UI BULLETIN # 76, REV. 1

SUBJECT: PTO (TCC Lockup) Inoperative
w/ Allison Automatic Transmission.

MODELS AFFECTED: Medium Duty C (Chevrolet
& GMC) C4500 – C7500 Series w/ 6.6L Diesel or 8.1L
Gas Engines and Allison Automatic Transmission.

Power Take-Off (PTO) Inoperative or Not Operating Properly (Check TCM Feedback Signal, Modify Wiring If Necessary) #06-08-131-001A - (May 08, 2006)

2006 Kodiak/TopKick PTO and Neutral Lockup Wiring - Allison 4th Generation Controls (As Received/Pre-Rework)

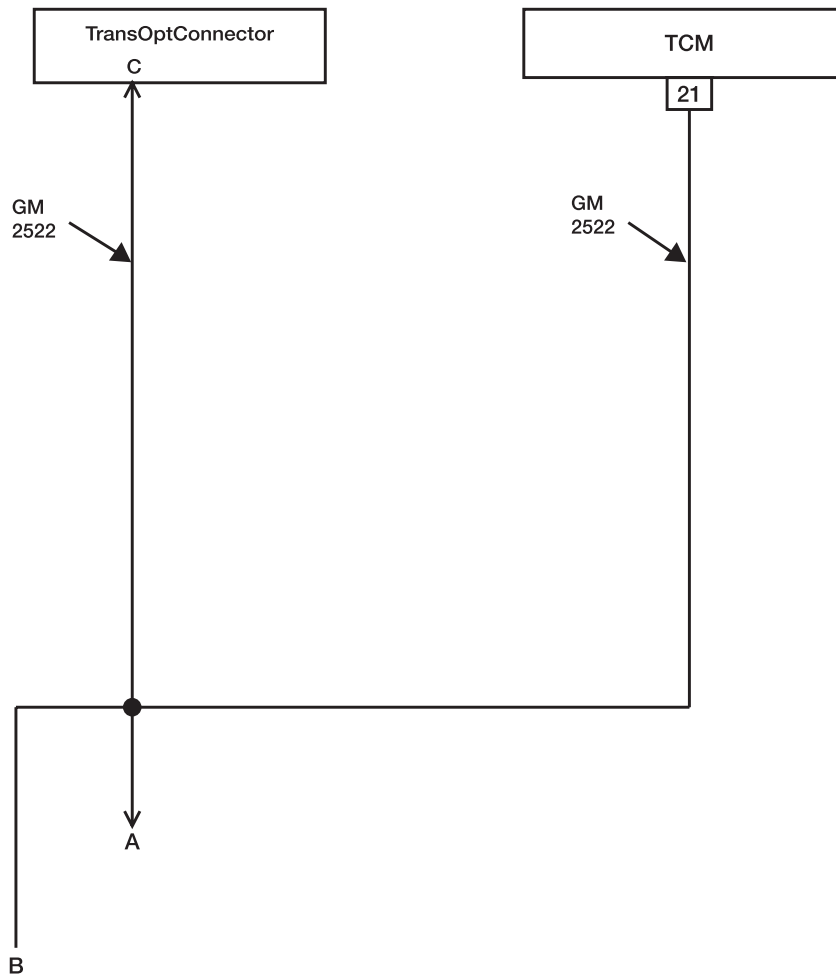
The illustration above shows the PTO feedback circuit for vehicles as built from the factory, without the required modifications. "A" is the PTO feedback to the ECM/PCM. "B" is Pin G of the Upfitter Connector on the vehicle harness (wire 2522).

2006 TopKick/Kodiak PTO and Neutral Lockup Wiring - Allison 4th Generation Controls (Required Modifications)

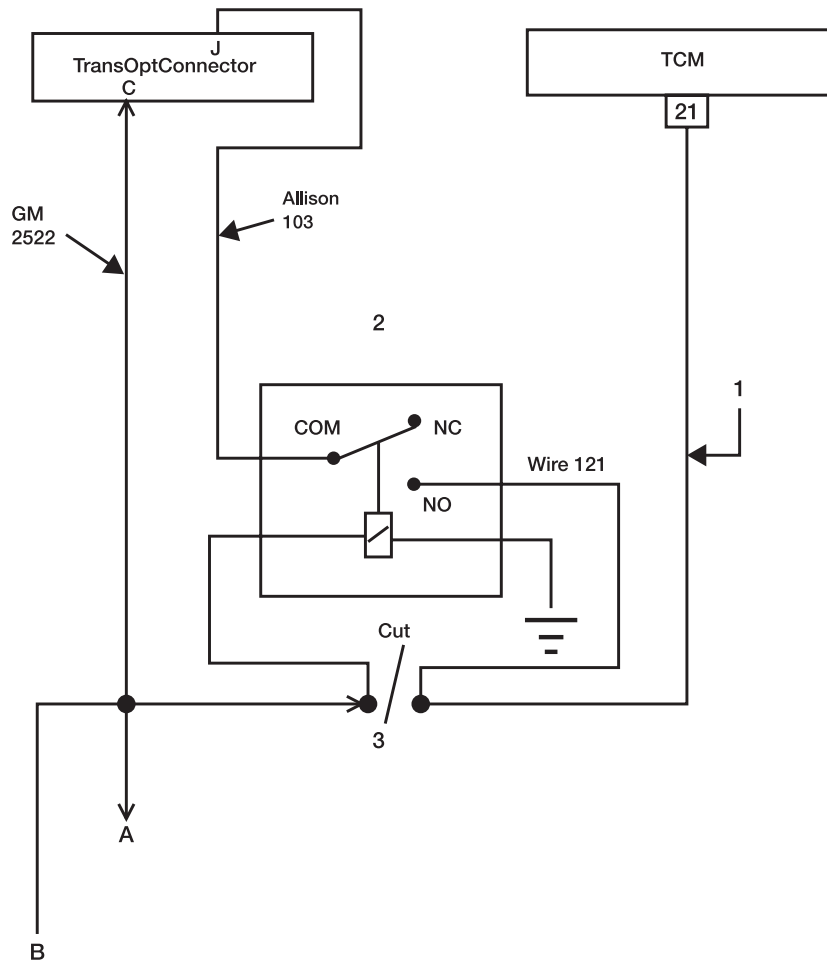
The illustration above shows the modification required for vehicles that have a PTO installed and require TCC lock-up during PTO operation. The wire (circuit 2522) must be cut between TCM terminal 21 and PCM terminal J1-52 (L18 engine) or J1-08 (LLY engine). After cutting the wire, a relay must be installed as shown. With the relay installed, a high signal (12-volt) is sent to the PCM's feedback terminal and a low signal (0-volt) is sent to the TCM's feedback terminal, when the PTO is engaged. Refer to the procedures below to make the required modifications. The location for each step are also shown in the illustration.

1. This was originally GM wire 2522, if present. Remove the wire and terminal from the TCM or cut the wire as shown in the illustration. Connect the wire to the “Normally Open” terminal on the relay to Pin 21 on the TCM with the new wire if needed. Refer to Repairing Connector Terminals in the AFL/EPC Connector repair section of SI for information on connecting terminals to wires. If GM wire 2522 is not present, install a new wire between pin 21 on the TCM and “Normally Open” terminal on the relay. Now call this wire 121.

2. Add wire 103 from Pin J of the TransOpt connector to the common (COM) terminal of the relay.
3. Cut wire 2522 and connect to the relay as shown. Make sure that wire 2522 is cut close to the TCM so that the break is made between the TCM and splice point S121. refer to Splicing Copper Wires Using Splice Sleeves in SI. If the wires are too short, tape wire 2522 on the vehicle side of the harness to itself. Then run a new wire from Pin “C” of the TransOpt connector to the positive (+) side of the relay coil. Ground the other side of the relay coil to the chassis ground.
